Addendum Number: 01

Addendum Issue Date: April 17, 2025

Project Name: Robinson Washington Elementary
Renovation & Addition

Project Number: 02401781.001

1 PLUMBING UNDERSLAB PLAN - AREA A
SCALE: 1/8" = 1'-0"

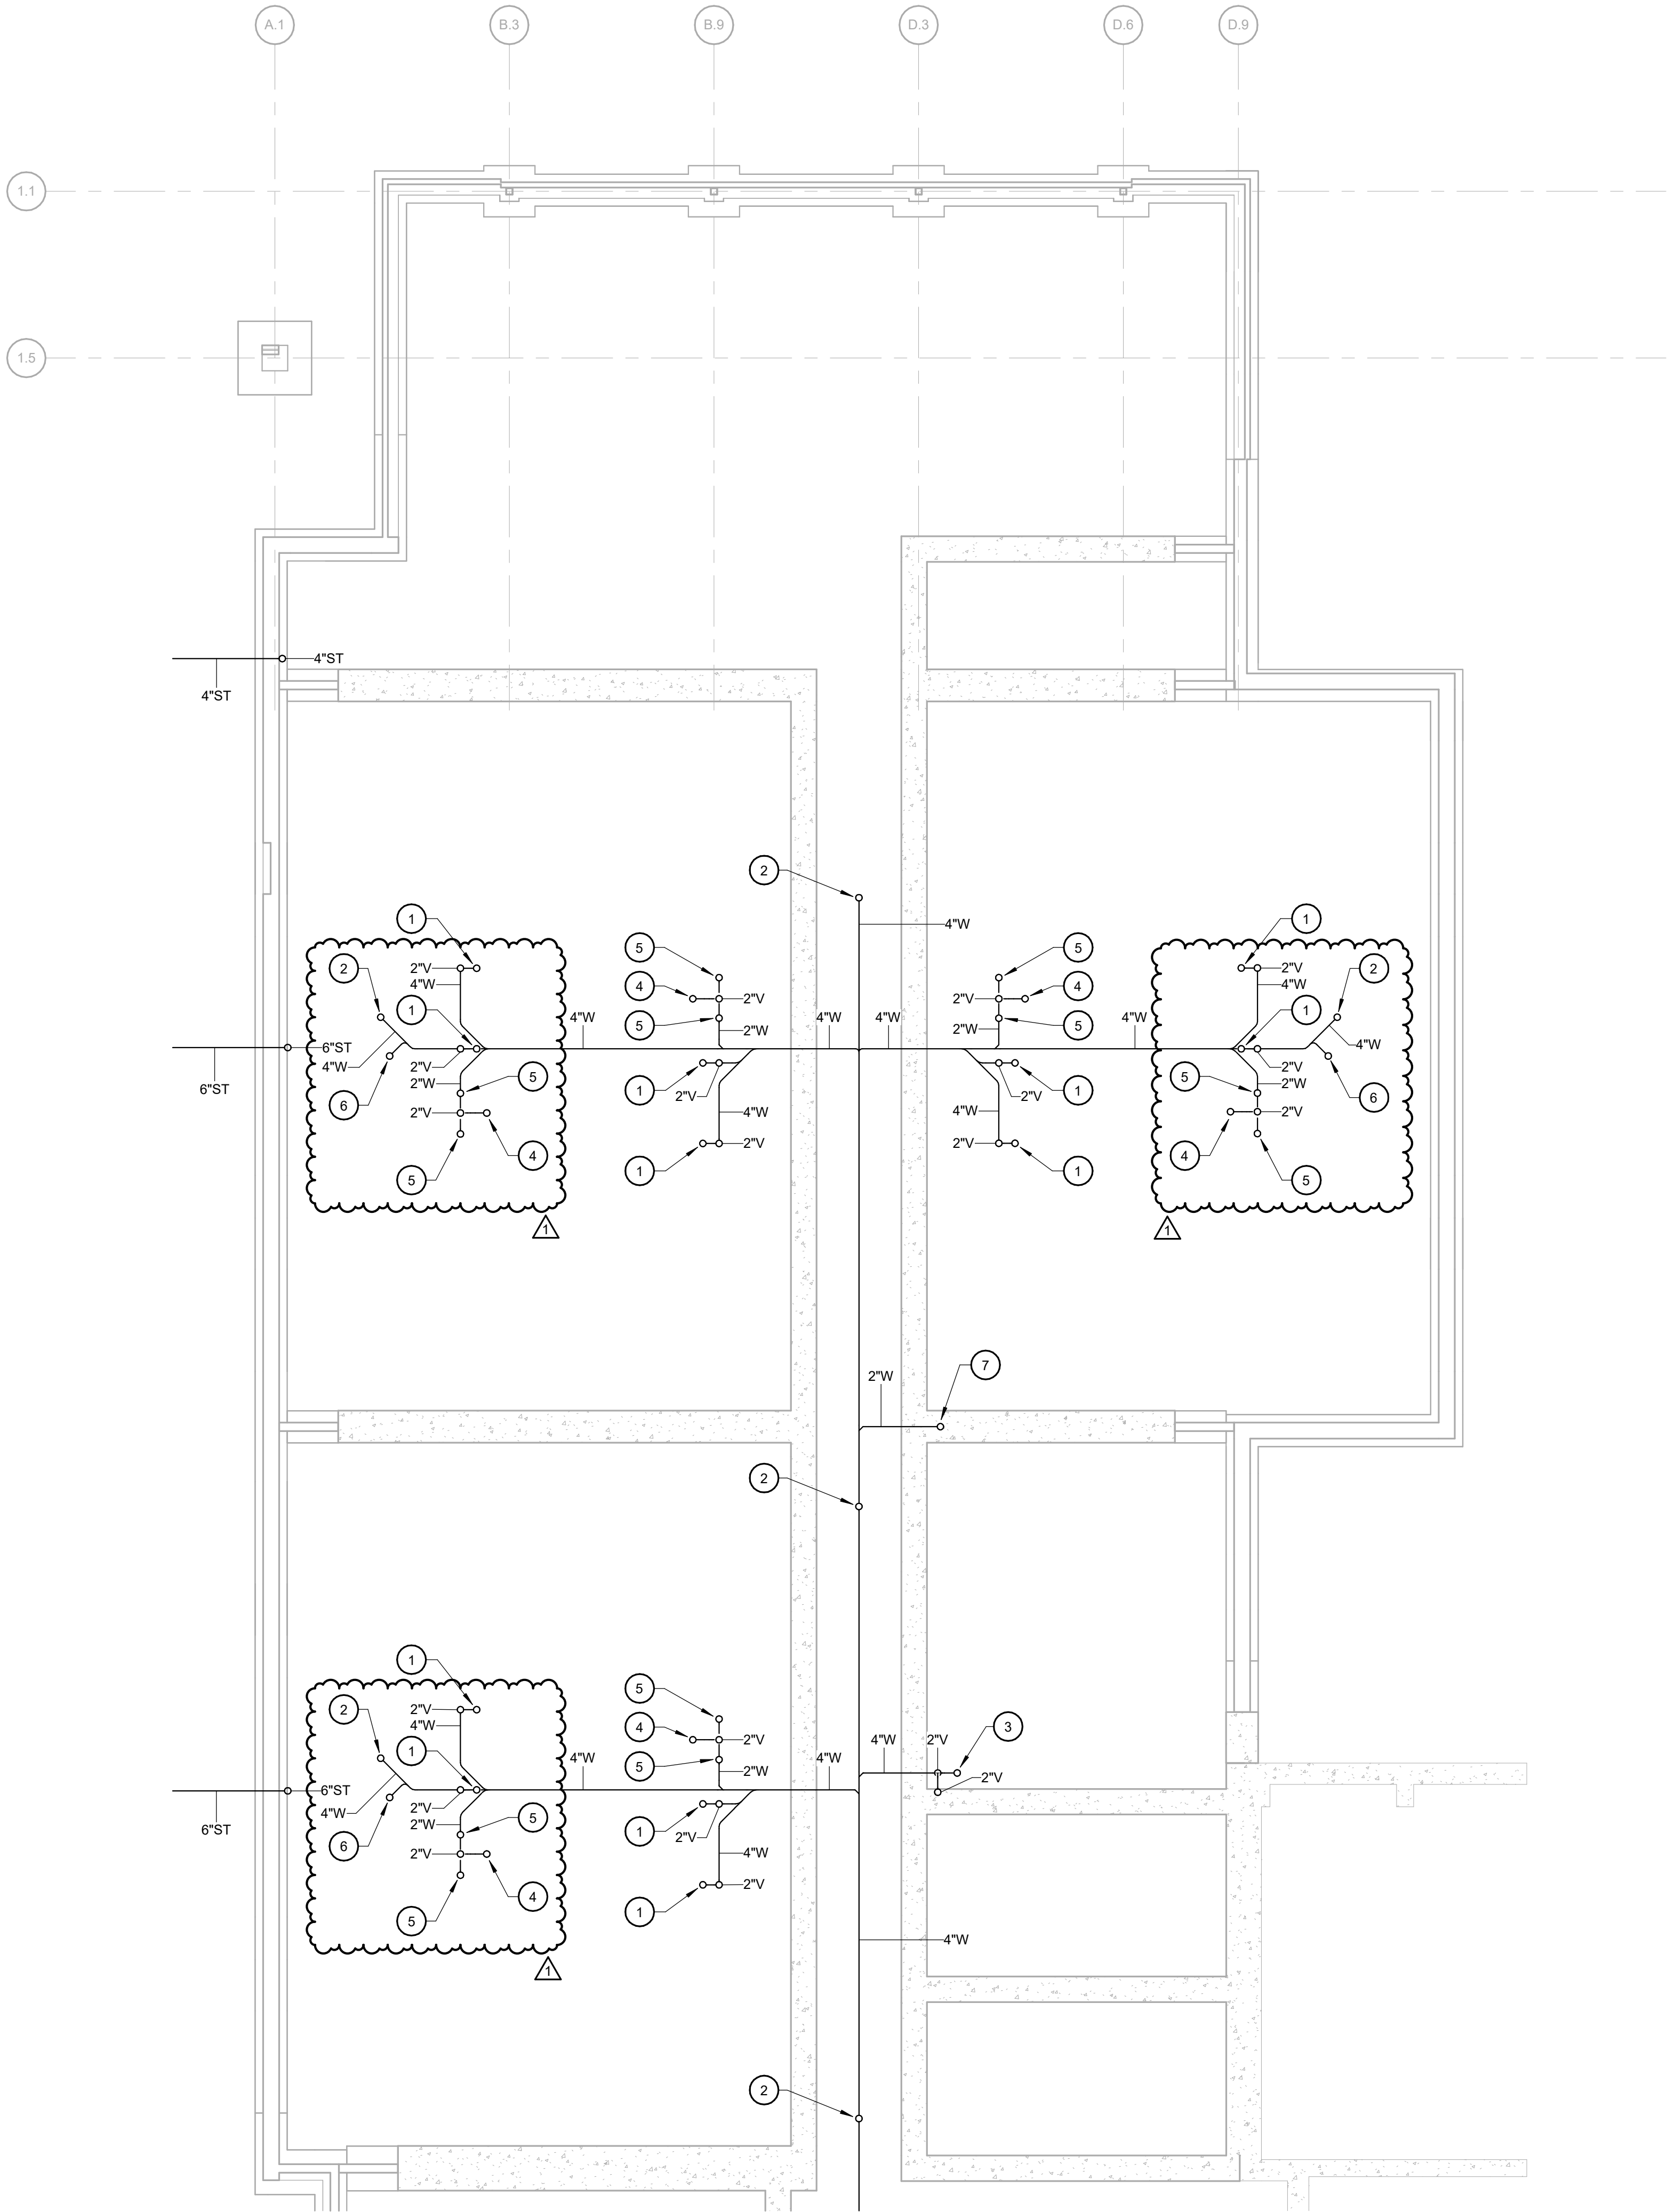
- a. REVISE sink waste piping for new sink locations in all preschool rooms.
- b. REVISE associated keynote for 2” waste up to sinks.

1 ENLARGED MECHANICAL DEMOLITION PLAN - AREA E

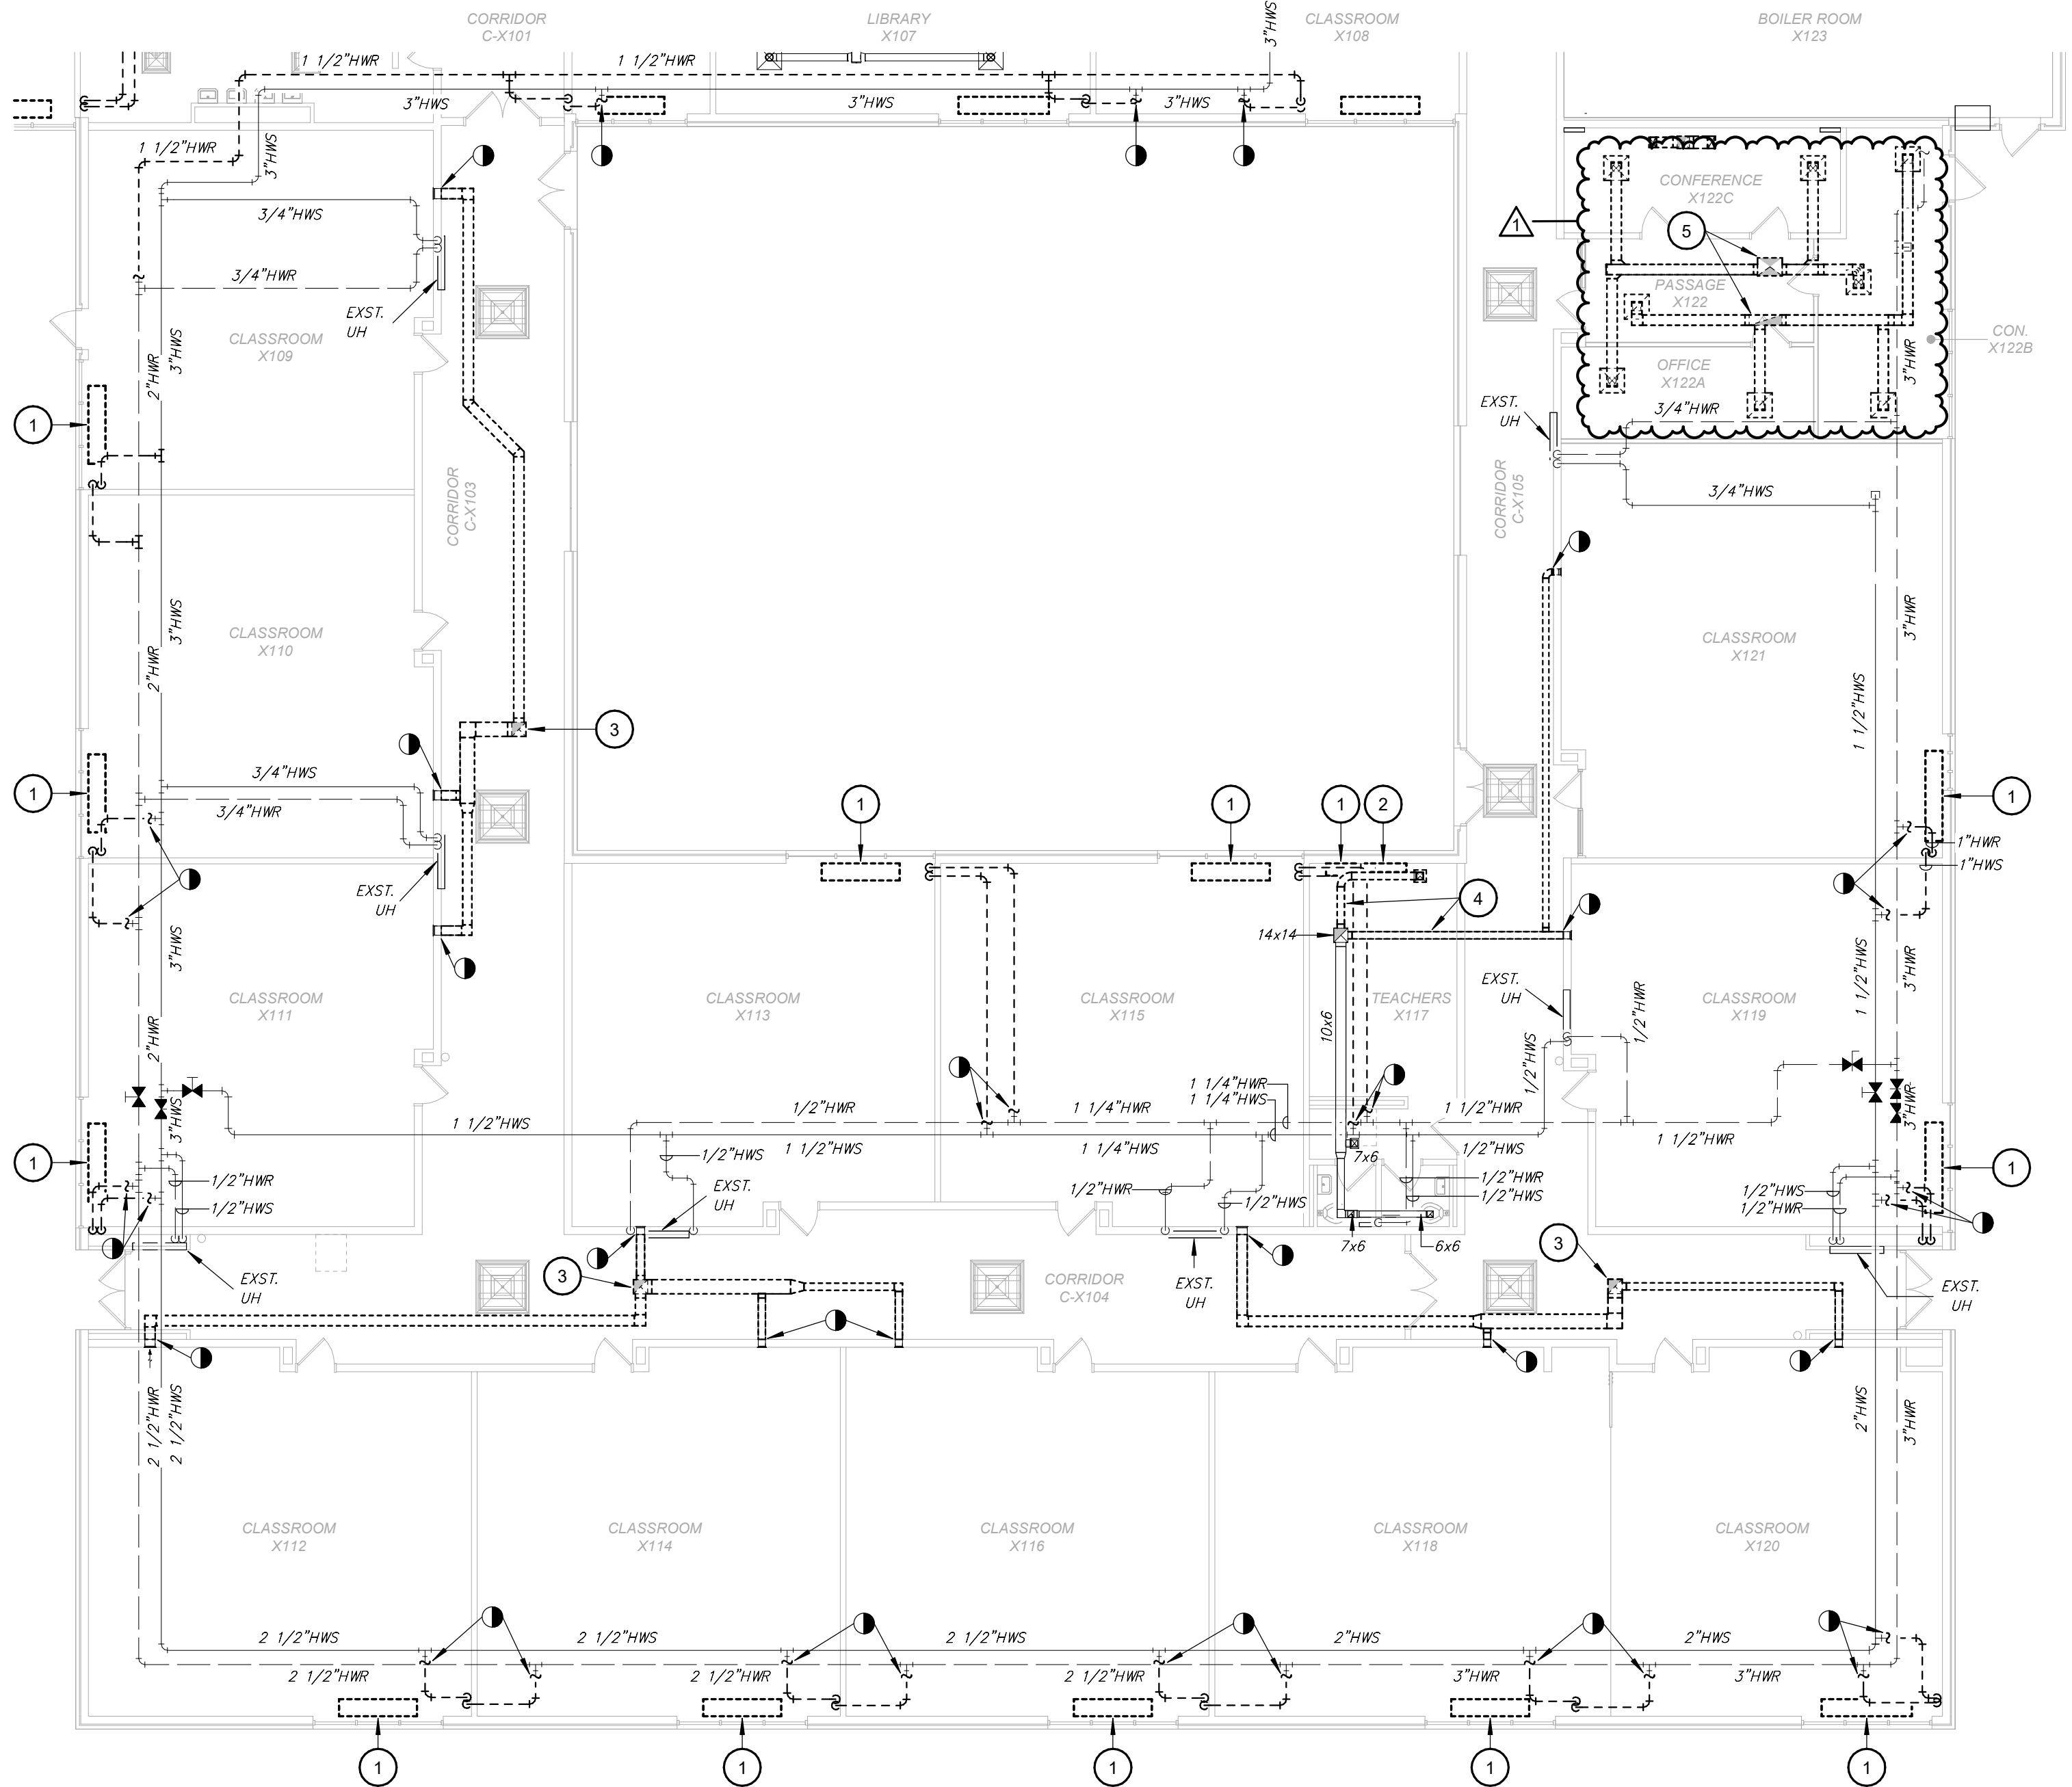
- a. REVISED ductwork demolition in X122, X122A, X122B, and X122C

ENLARGED VENTILATION FLOOR PLAN - AREA D

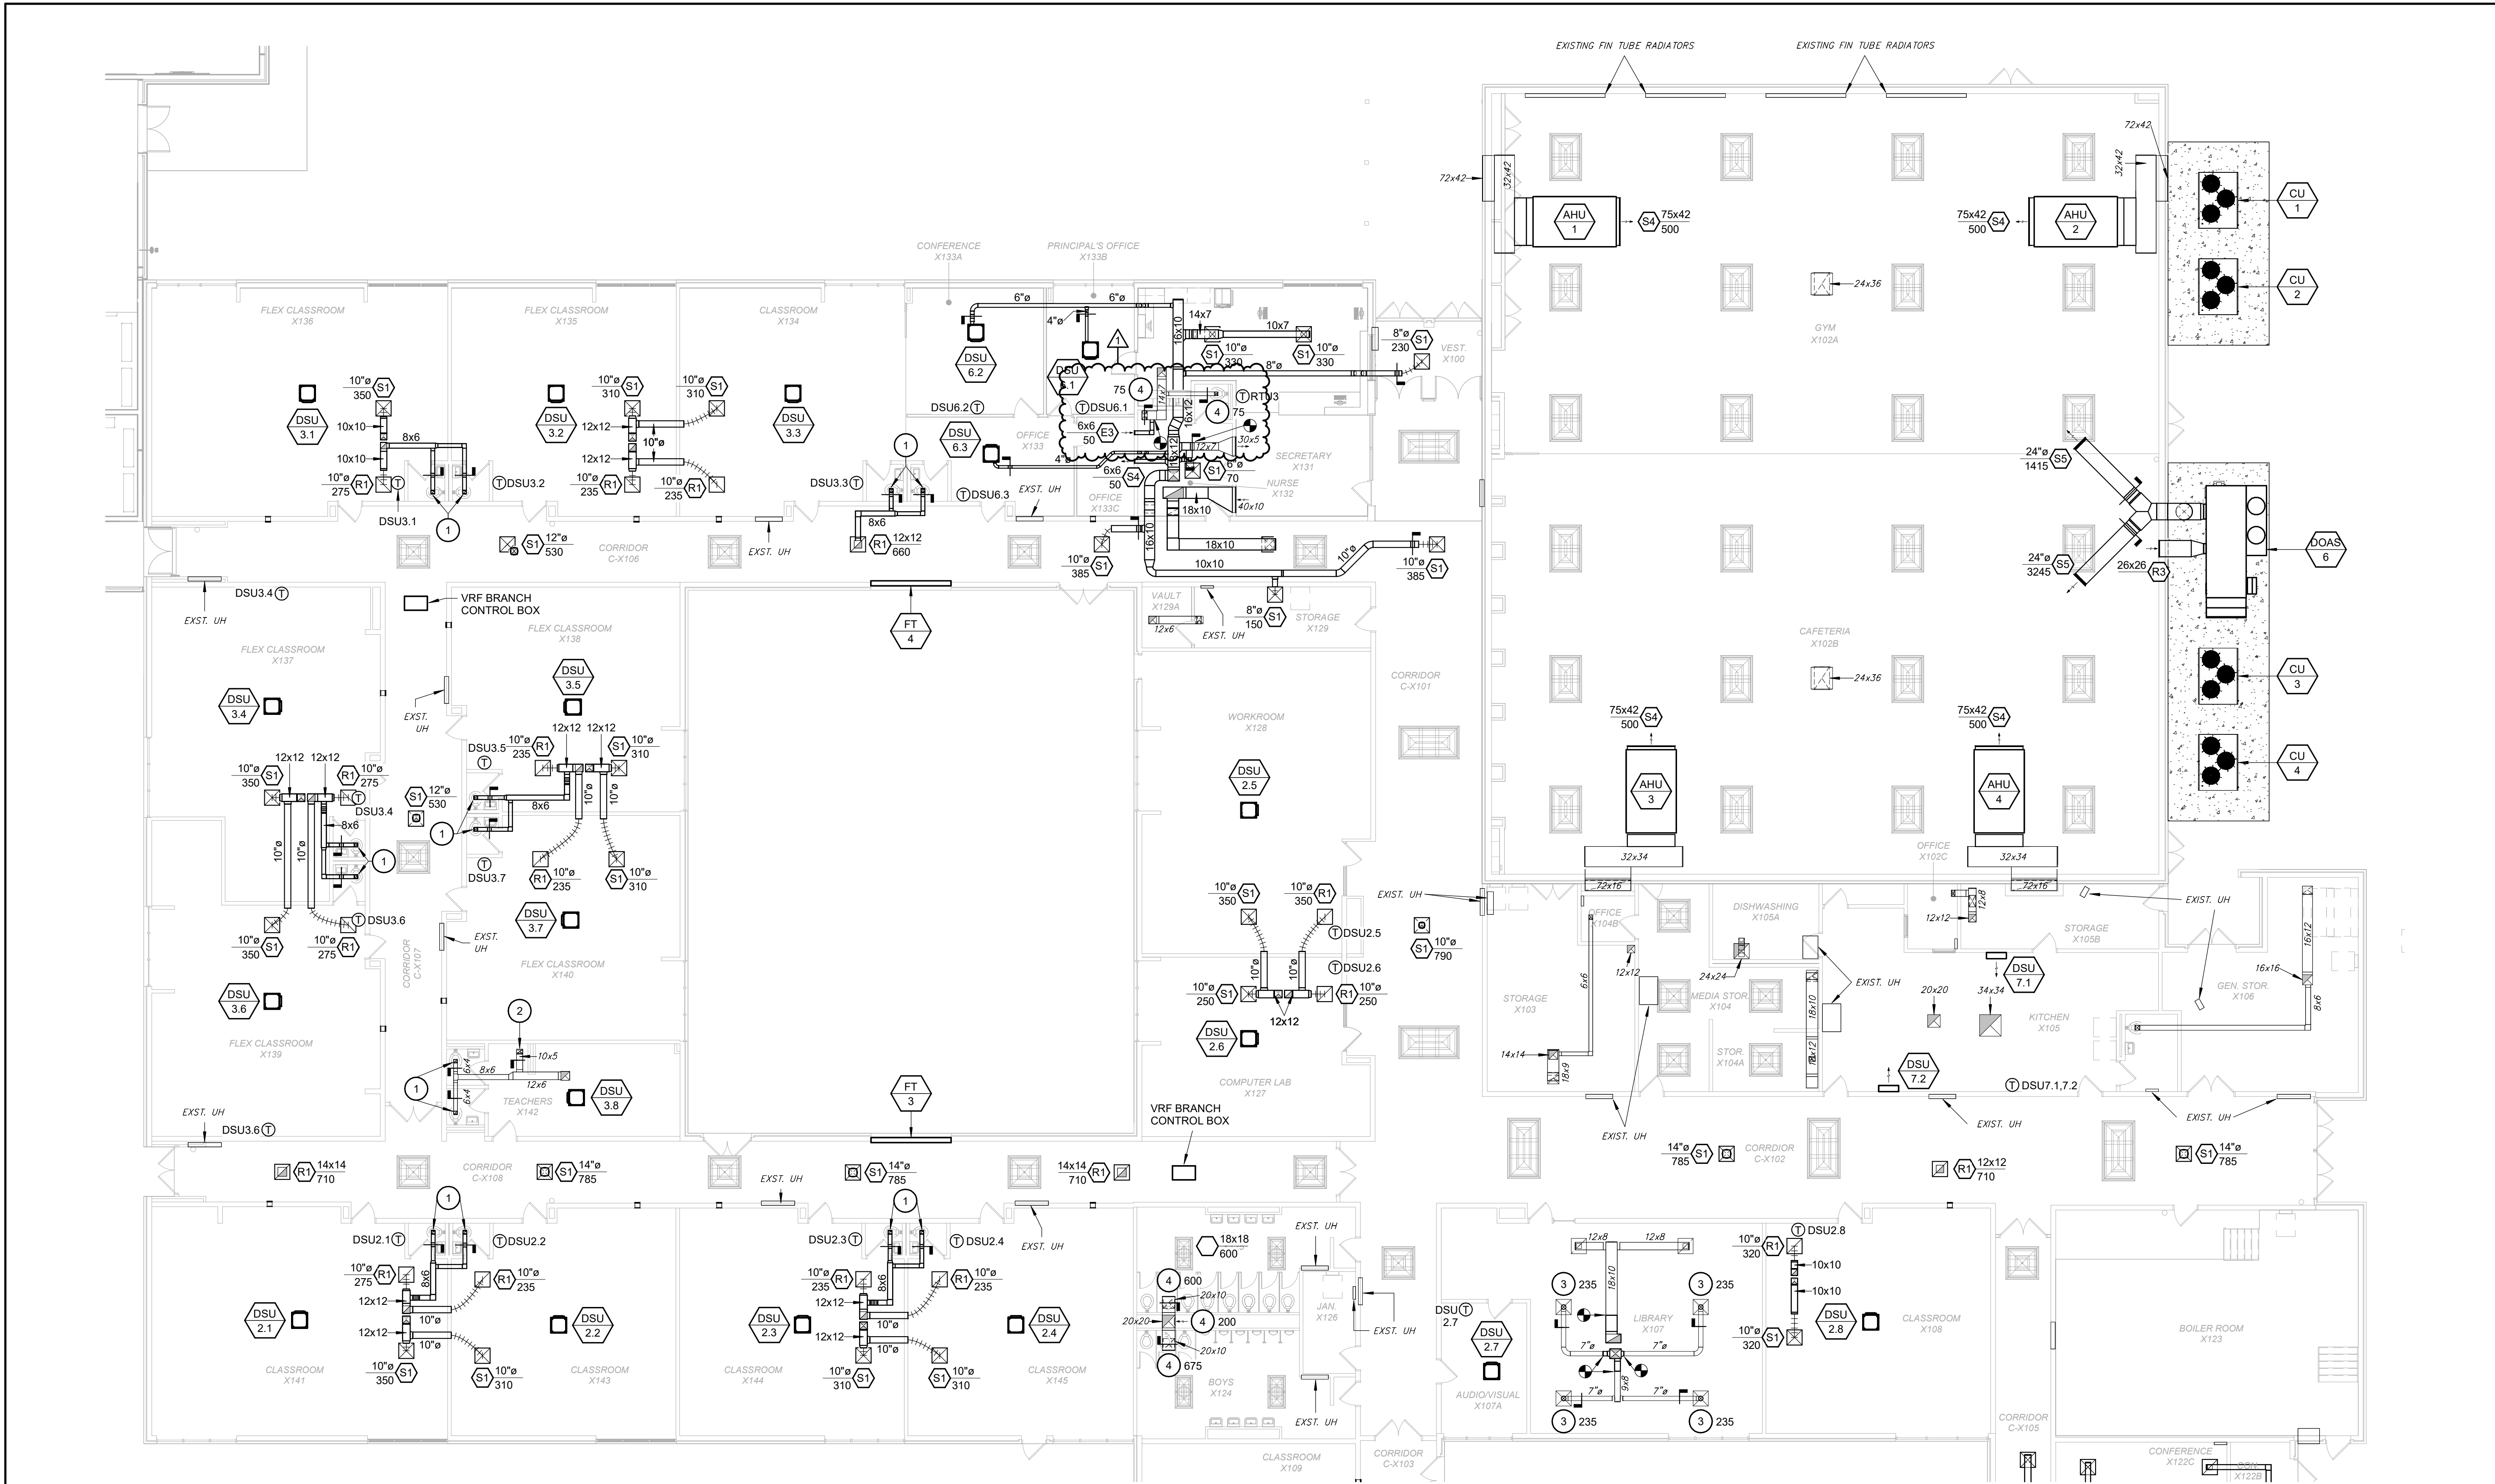
- a. ADD exhaust ductwork and exhaust air grille to serve Office X133C
- b. ADD Keynote #4 to exhaust air grilles in Nurse X132 and Toilet X132A, to show new air balances.
